12 GROUNDWATER

12.1 CONCEPTUAL GROUNDWATER MODEL

12.1.1 MODELLING

Figure 12.2 Cross-section A-C showing interpreted hydrostratigraphic and structural relationships north of Olympic Dam toward Billa Kalina spring

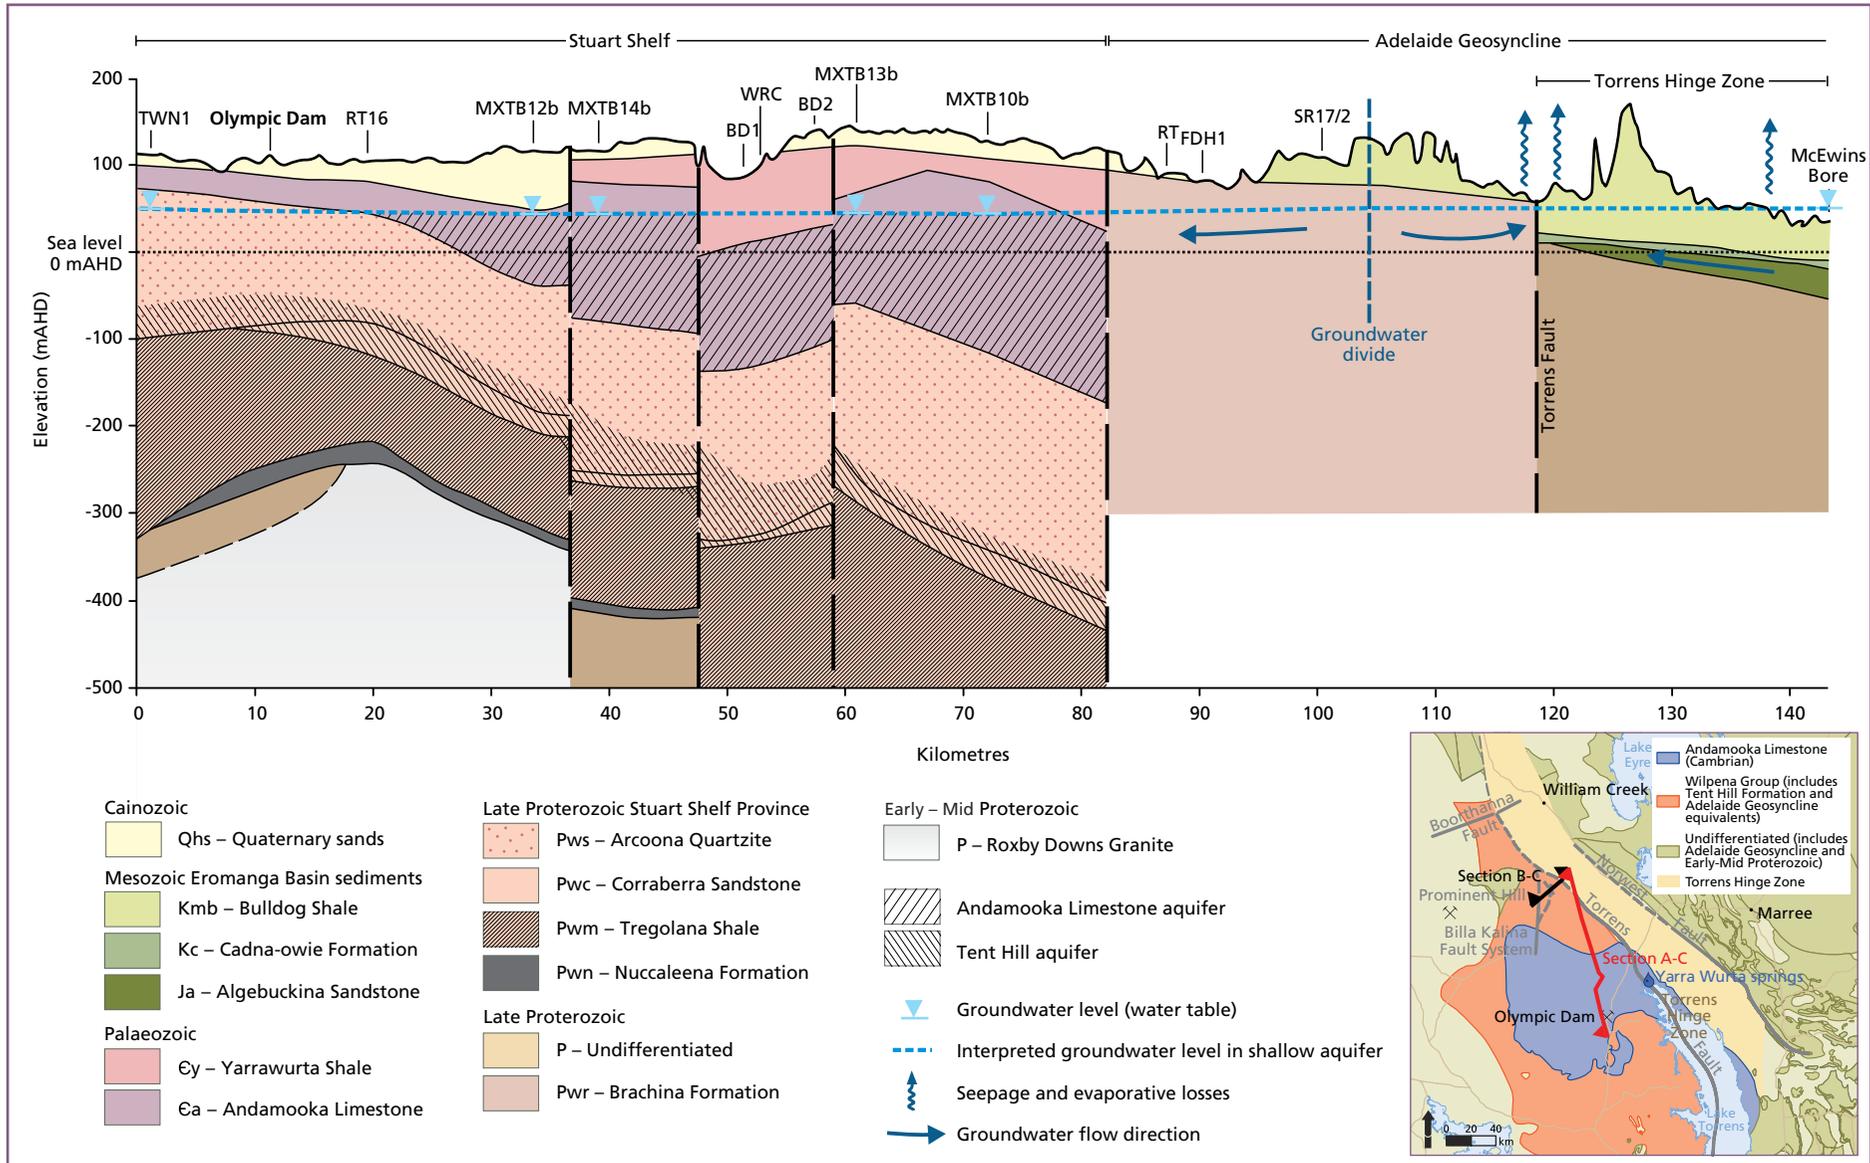
- the barrier between the Great Artesian Basin (GAB) and Stuart Shelf, with a specific request for the presentation of a hydrogeological cross-section from Olympic Dam to Billa Kalina Springs
- the inferred geological and hydrogeological interfaces between the Stuart Shelf, GAB, Torrens Hinge Zone and Adelaide Geosyncline, including inferred groundwater flow behaviour and hydraulic separateness
- the hydrochemical distinctness of individual aquifers
- inferences of linkages between the Arckaringa Basin (Boorthanna Formation) and Stuart Shelf groundwater systems
- the presence of the Andamooka Palaeochannel in the mining lease area
- observed groundwater system response to the existing mining operation and inferences that can be drawn regarding the predicted response for the proposed expansion.

Figure 12.2 shows:

Figure 12.10a Predicted drawdown in the Tent Hill aquifer from the updated groundwater model

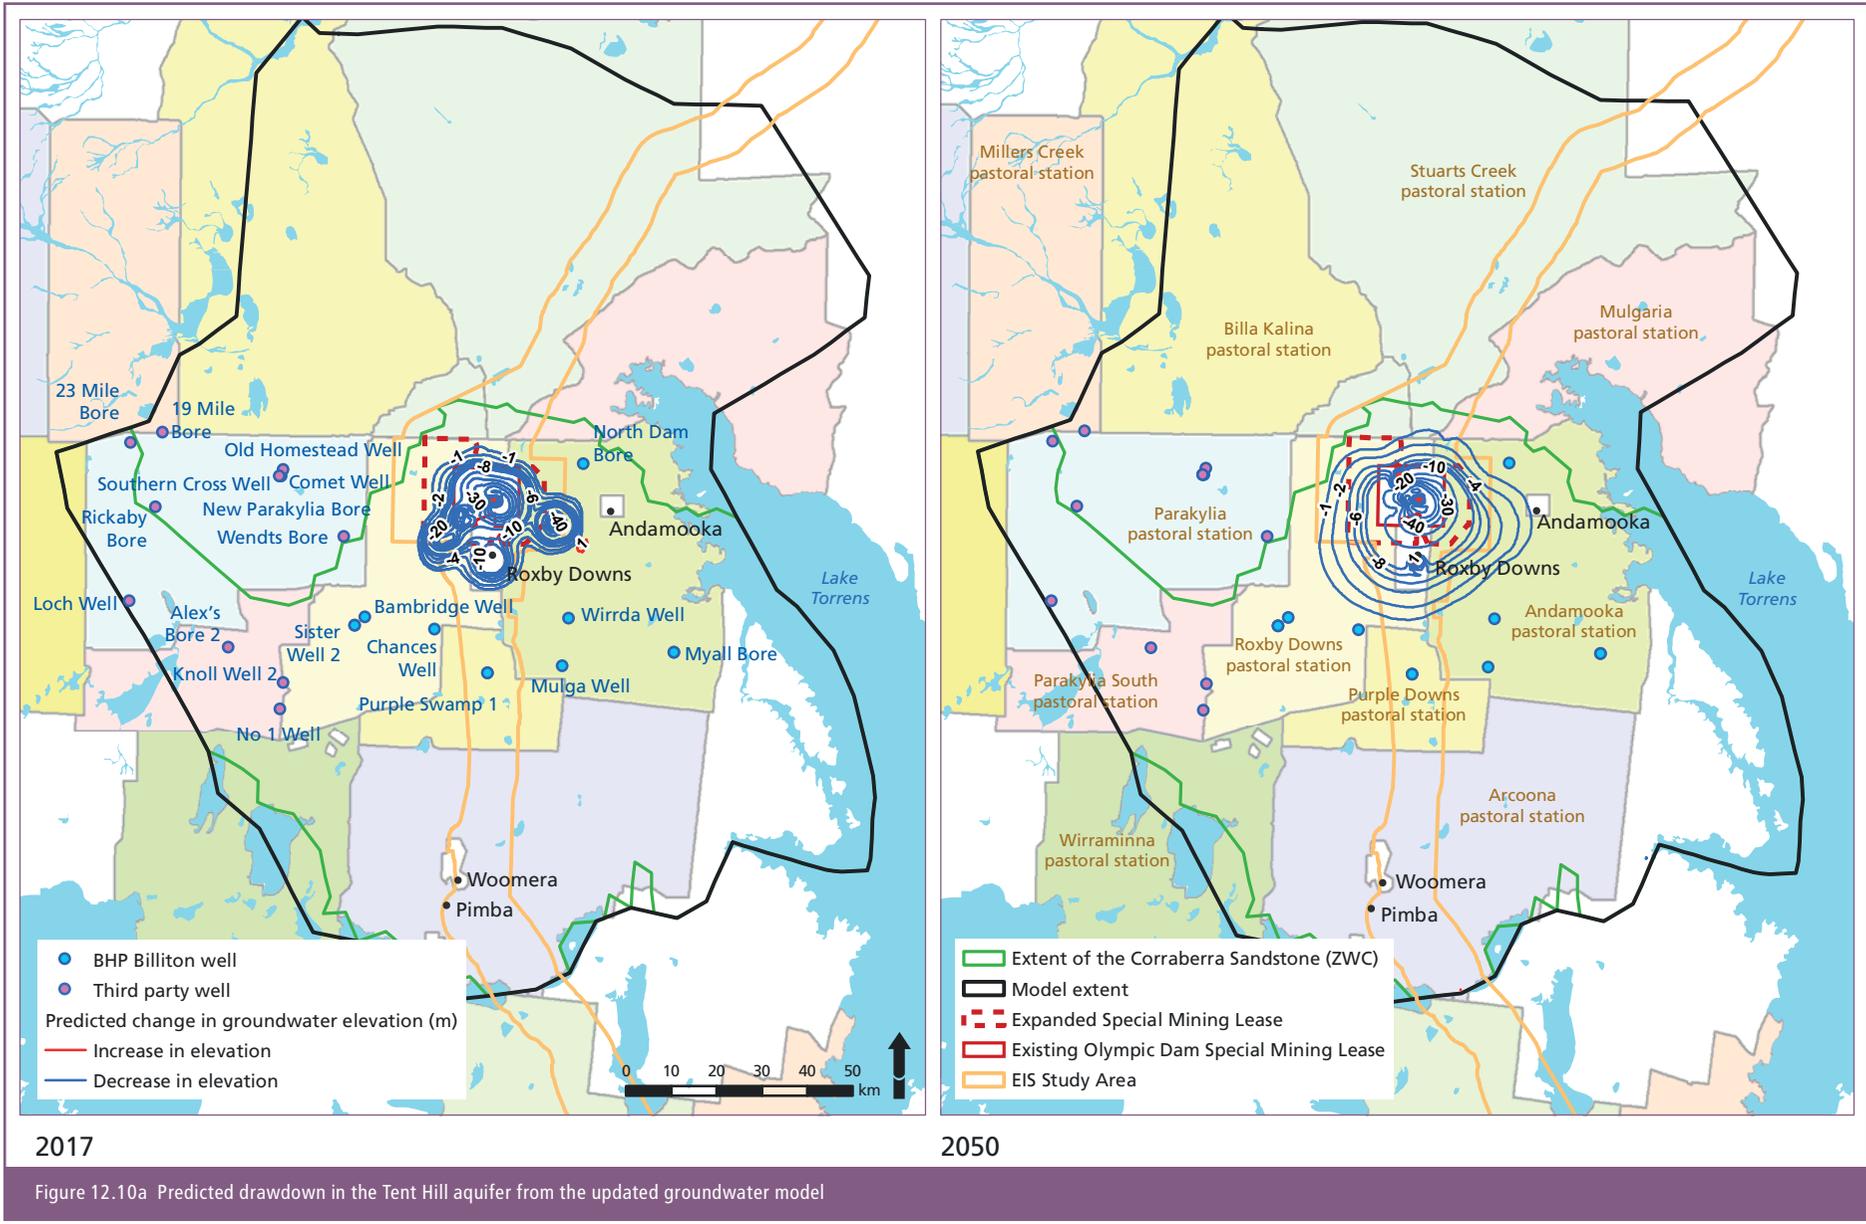
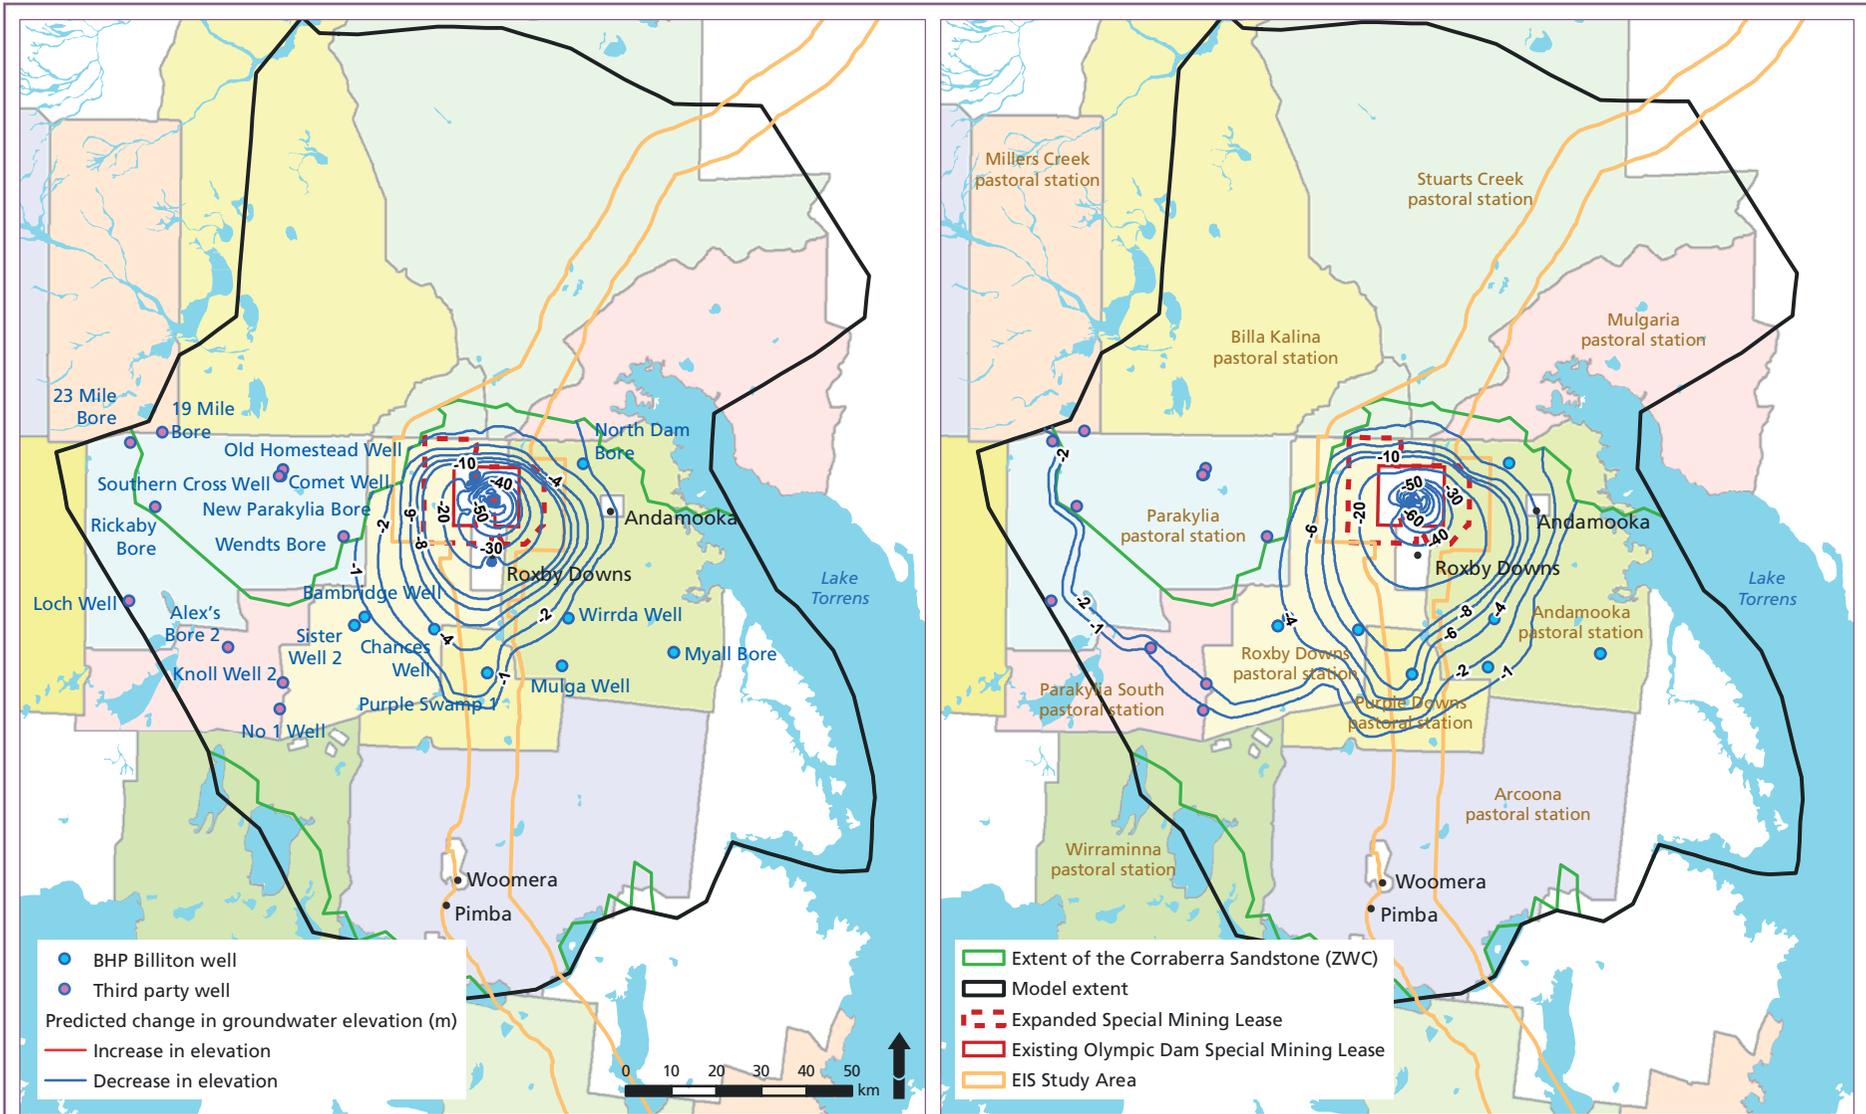
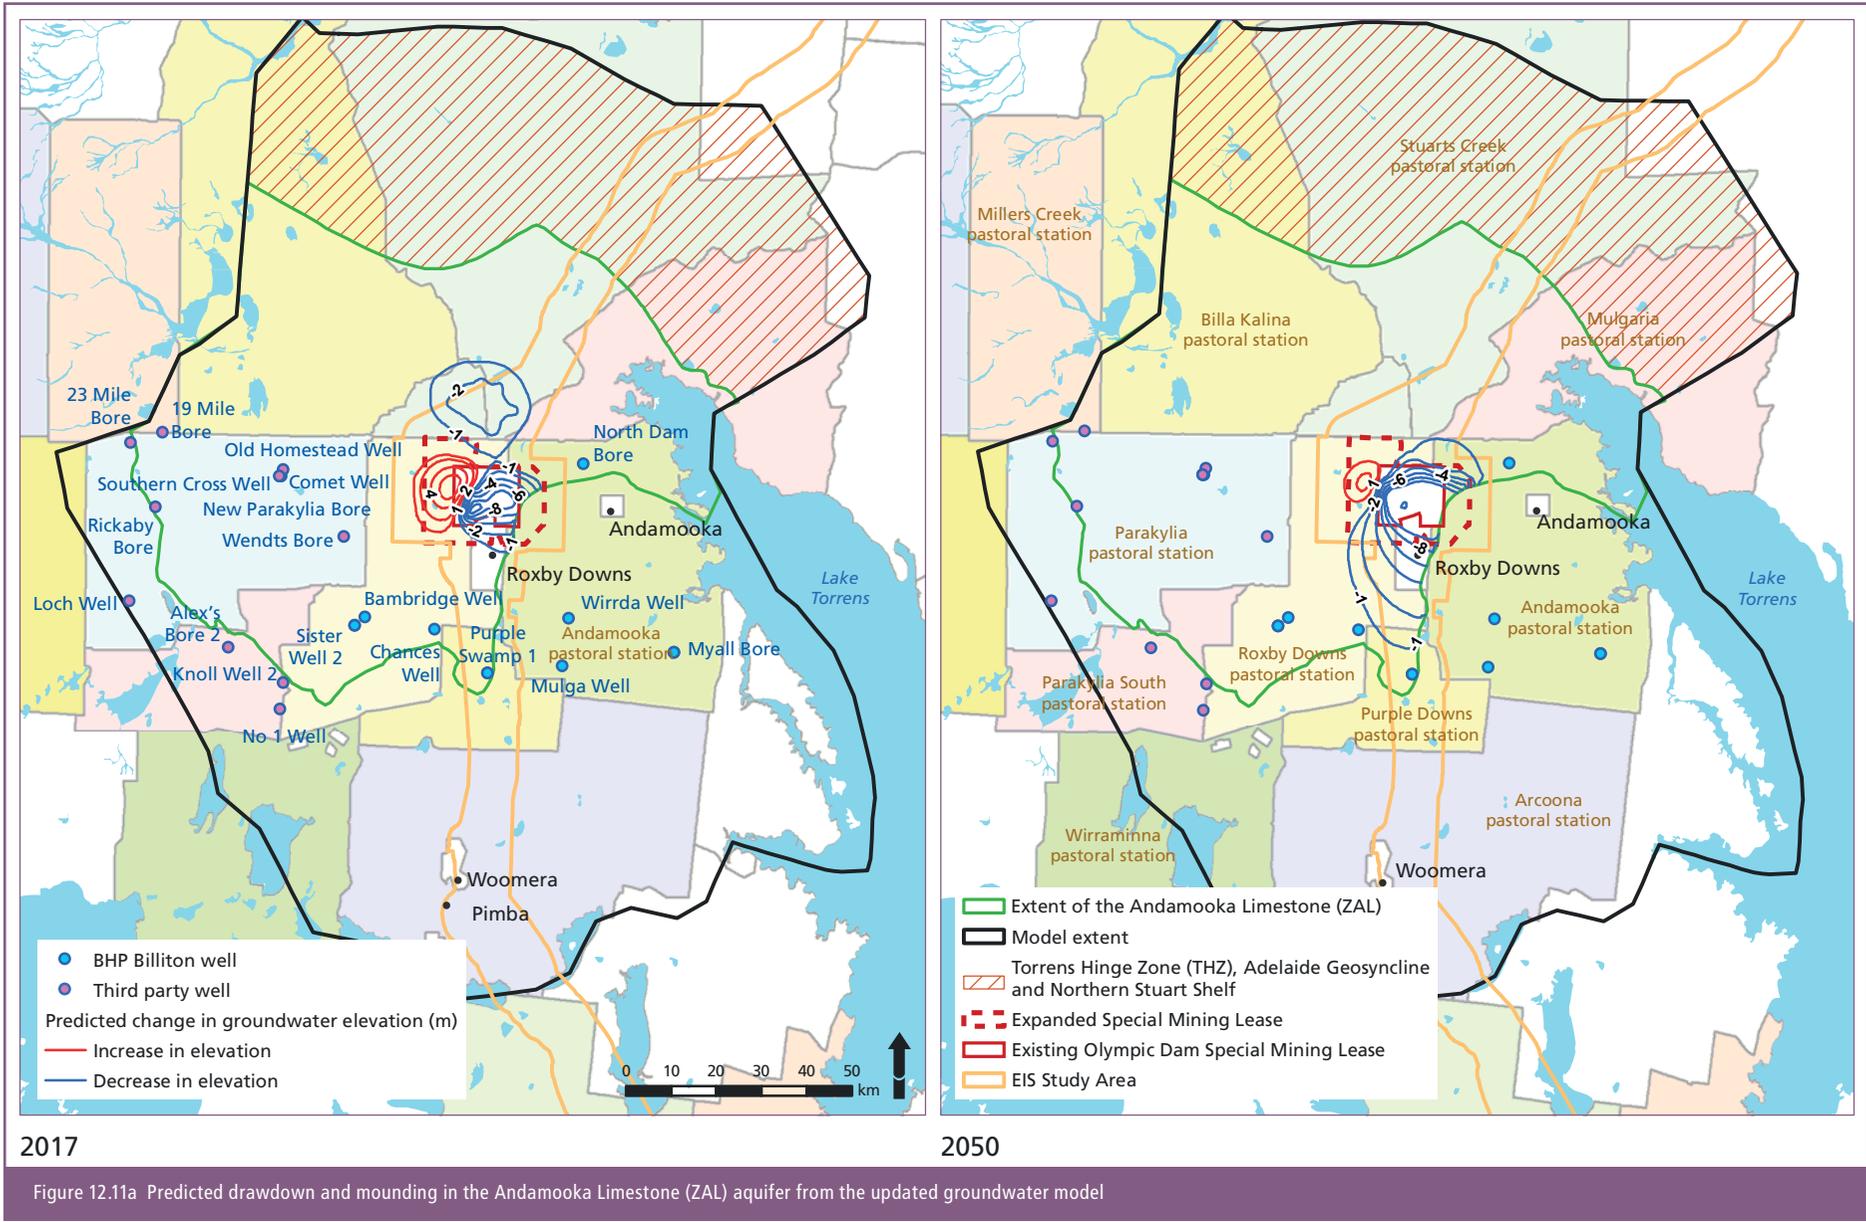
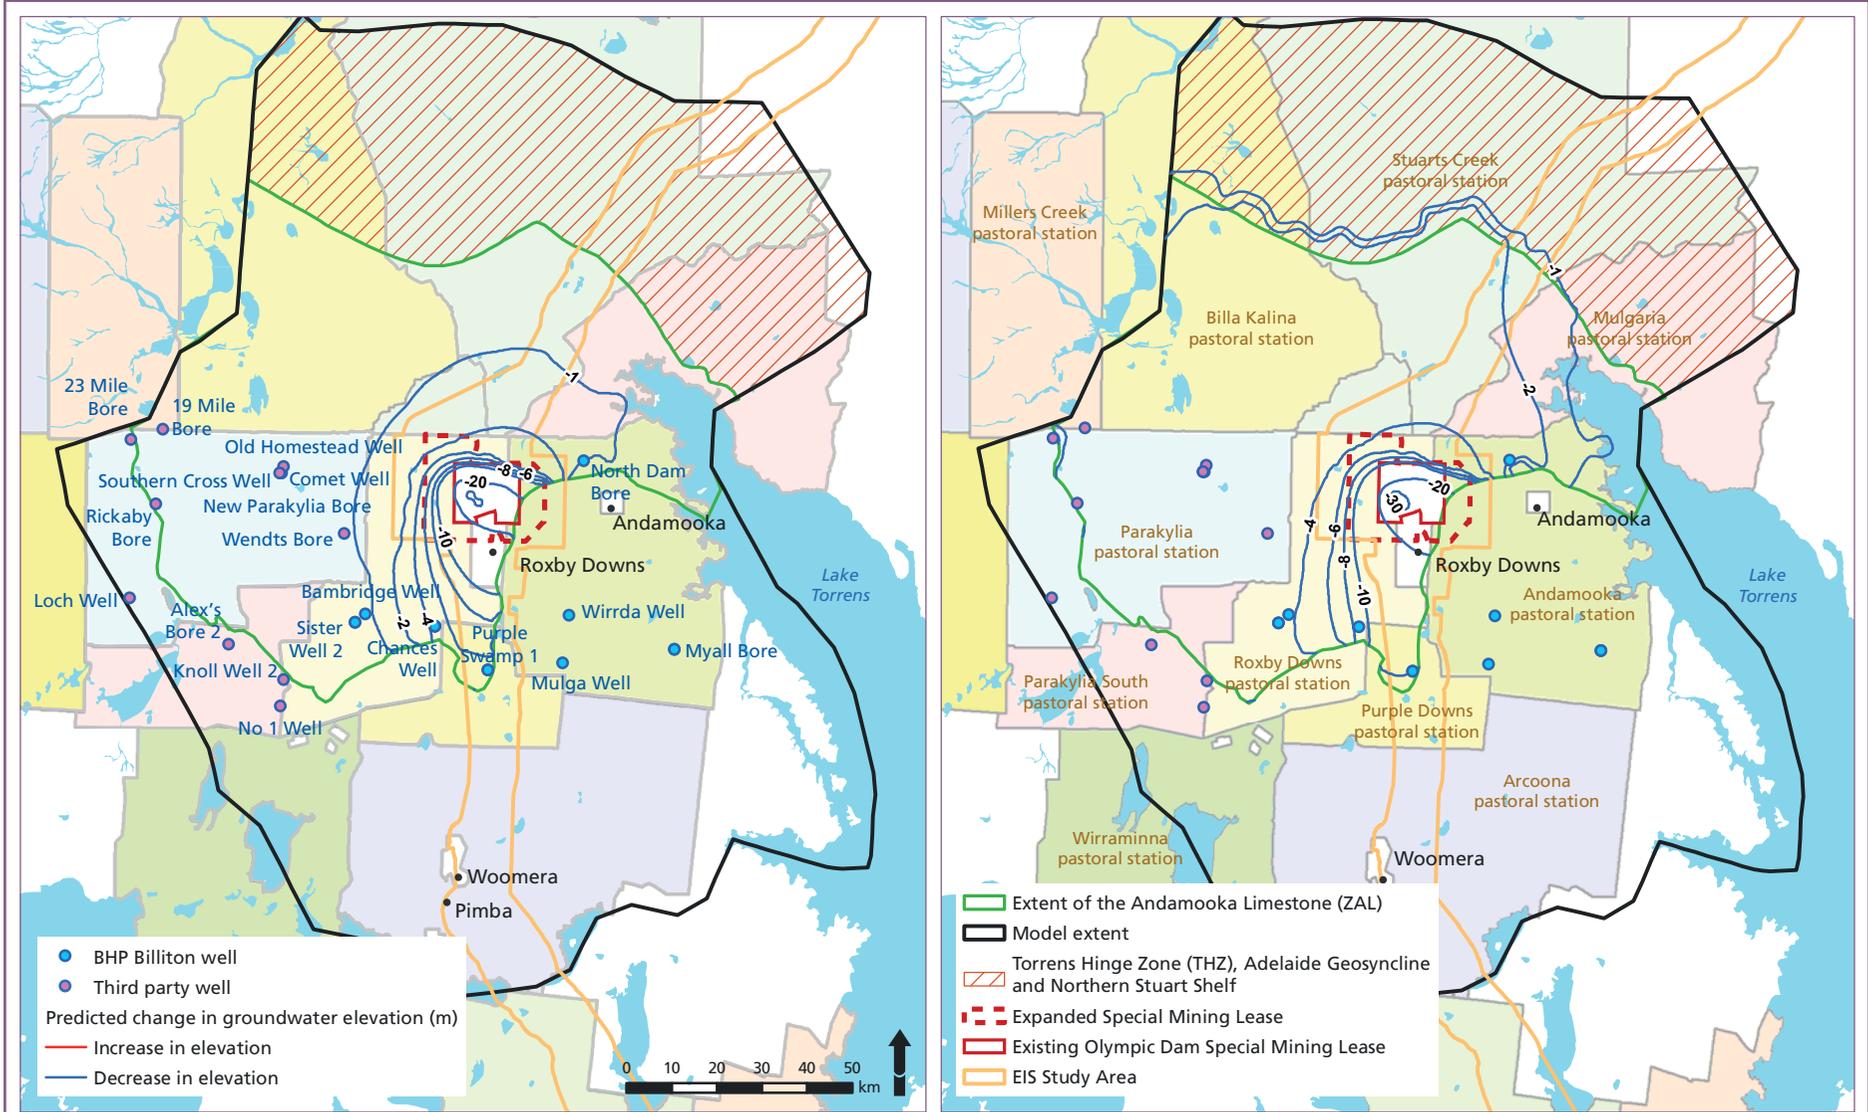
The potential impacts from groundwater drawdown on local aquifers, and on flora and fauna were questioned.

Based on the updated modelling, the final zone of influence (500 years post-closure) in the Tent Hill aquifer is expected to be around 65 km west and 40 km south, with the majority of drawdown occurring within 20 km of the expanded SML, as presented in Figure 12.10b. The modelled drawdown at 500 years post-closure in the Andamooka Limestone aquifer is expected to be around 55 km north and 25 km south in the Andamooka Limestone aquifer, with the majority of drawdown occurring within 15 km of the expanded SML, as presented in Figure 12.11b.
